Access Compliance Report Public Rights-of-Way (Curb Ramps)

Intersection ID: 10041752 Main Street: WILKINSON_BV Cross Street: N/A Location: NE

ADA ID: 5CCF1FF98AC6 Ramp Type: BlendTrans1 Initial Pass/Fail: Fail Overall Compliance: No Severity Score: 10

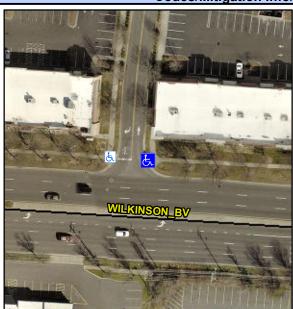
Not Found, R304.5.1, R304.5.3

Field Measurements/Component Compilance					
Compliance Description			Compliance Description		Data
N/A	Ramp Length (in)	61.0	Yes	BlendTrans Slope (%)	0.6
No	Ramp Width (in)	45.0	No	BlendTrans XSlope (%)	3.9
N/A	Flare Type LT	N/A	N/A	Flare Type RT	N/A
N/A	Flare Slope LT (%)	N/A	N/A	Flare Slope RT (%)	N/A
N/A	Flare Traversable LT?	N/A	N/A	Flare Traversable RT?	N/A
N/A	Landing Length (in)	N/A	N/A	DWS Provided?	N/A
N/A	Landing Width (in)	N/A	N/A	DWS Contrast?	N/A
N/A	Landing Slope (%)	N/A	N/A	DWS Length (in)	N/A
N/A	Landing X Slope (%)	N/A	N/A	DWS Full Width?	N/A
N/A	Landing Curb? (Y/N)	N/A	N/A	DWS Offset (in)	N/A
N/A	Shared Landing?	N/A			
N/A	Gutter Ponding?	N/A	N/A	Gutter Slope (%)	N/A
N/A	Gutter Lip Ht (in)	N/A	N/A	Gutter X Slope (%)	N/A
N/A	Painted X Walk1?	No	N/A	Painted X Walk2?	N/A
	X Walk 1 Direction	To W		X Walk 2 Direction	N/A
	X Walk 1 Width (in)	N/A		X Walk 2 Width (in)	N/A
	X Walk 1 Slope (%)	0.6		X Walk 2 Slope (%)	N/A

X Walk 1 X Slope (%)	3.6		X Walk 2 X Slope (%)	N/A
N/A	Ramp inside XWalk1?	N/A	N/A	Ramp inside XWalk2?	N/A
	Road Slope (%)	3.6		Clear Space?	N/A
	Road X Slope (%)	0.6	N/A	Clear Space to XWalk (in)	N/A
N/A	Any Obstructions?	N/A	N/A	Storm Grate/Utility Hazard?	N/A
	Obstruction Type			Storm Grate/Utility Type	
		N/A			N/A
			Yes	Surface Condition? (G/P)	Good
			No	Curb Slope (%)	15.6

Remove & Replace Curb Ramp With Two New Directional Ramps or Equivalent.
